# Technical Service Information

## CHRYSLER 45RFE/55RFE BIND ON 3-4 OR 4-5 UPSHIFT

Figure 1

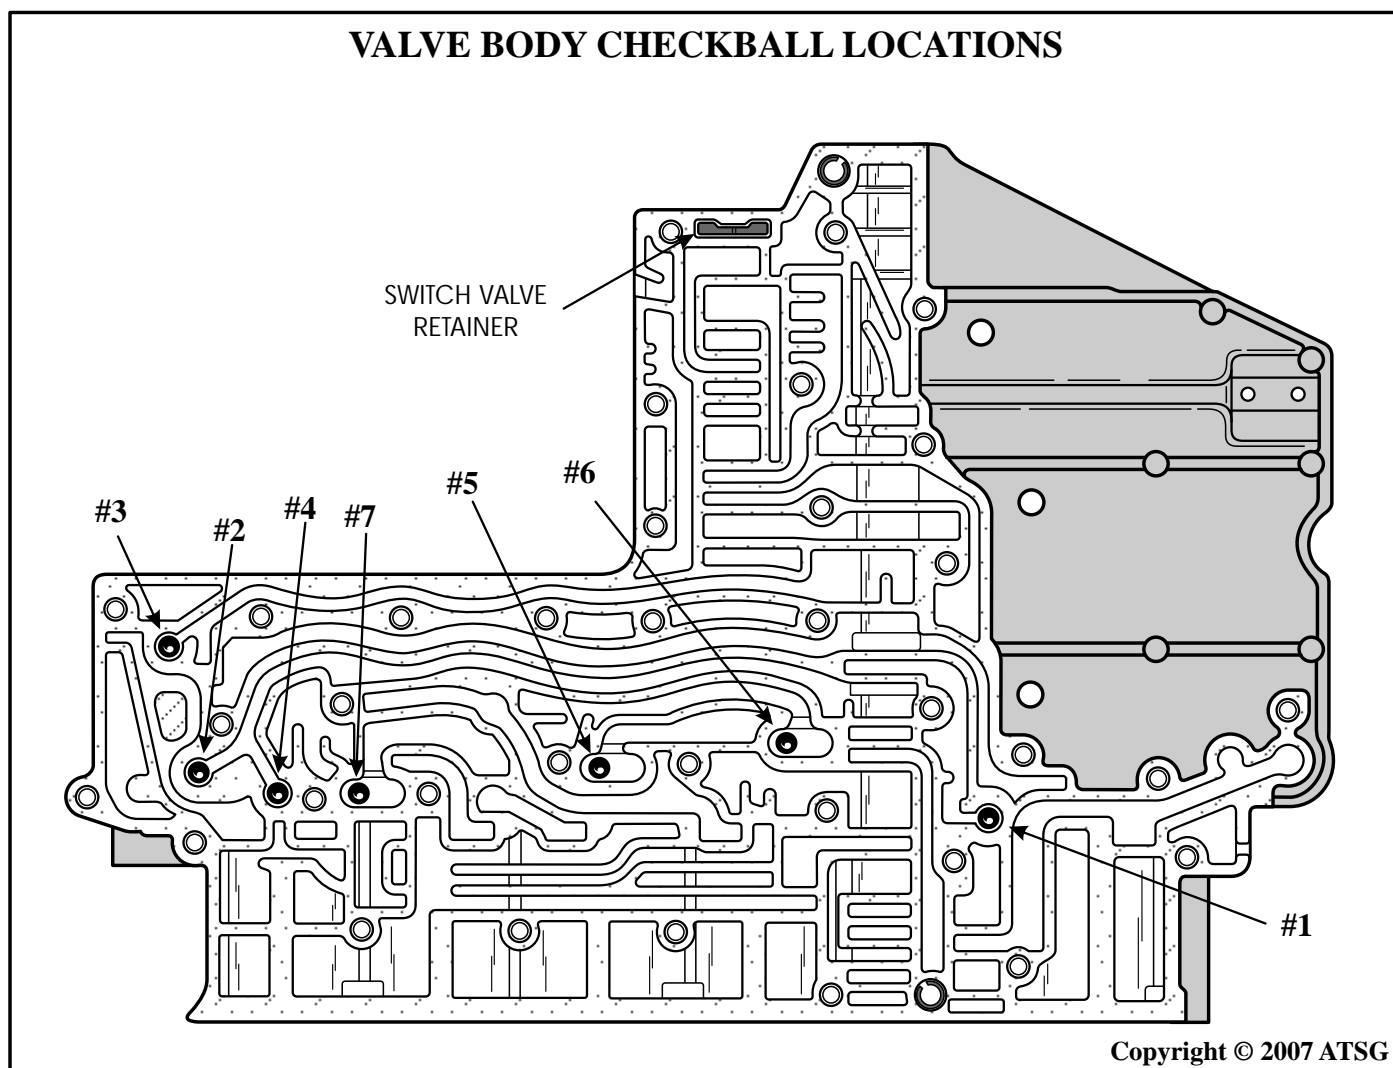
**CAUSE:** The cause may be that the #2 checkball, as shown in Figure 1 has partially disintegrated, allowing the underdrive clutch to be partially or fully applied when the 3-4 or 4-5 upshift occurs causing a bind-up.

**CORRECTION:** Replace the checkballs with new plastic checkballs available in aftermarket rebuild kits or from an O.E. supplier. For Valvebody Exploded views refer to Figures 2 and 3.
